Product hierarchy no. *	Part no.	SBU	Type / Description	Customer part no.			
SBU PG PUG Type				·			
80 084 002 0000006148	See list below	EMC	FSS-55				
*SBU (2-digit) / PG (3-digit) / PUG (3-digit) / Type (10-digit)

2 Type of change

Product Change Notification				PCN FSS-55 case 10 redesign			
owner	creation date	release date	released by	change order no	rev	page	D40 044 502
segatro	12.03.2020	12.03.2020	canoniar	2018652	В	1 of 2	D10-041-503

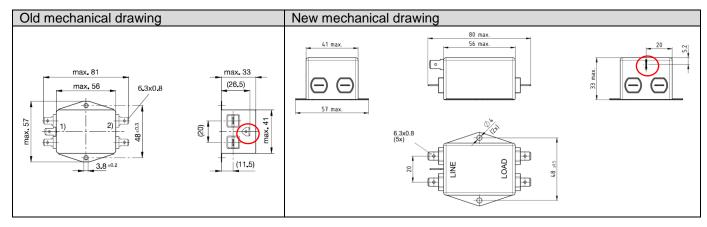
- Nickel plated steel case instead of aluminium case
- Different shape of external quick connect terminals
- Change of production site

- Change of product appearance due to new nickel-plated steel case instead of aluminium case
- Different shape of plastic part for external quick connector terminals
- Moved position and turned protective earth terminal to a vertical position
- Change of factory code from SK to SC and origin from SK to CN on product and packaging labels
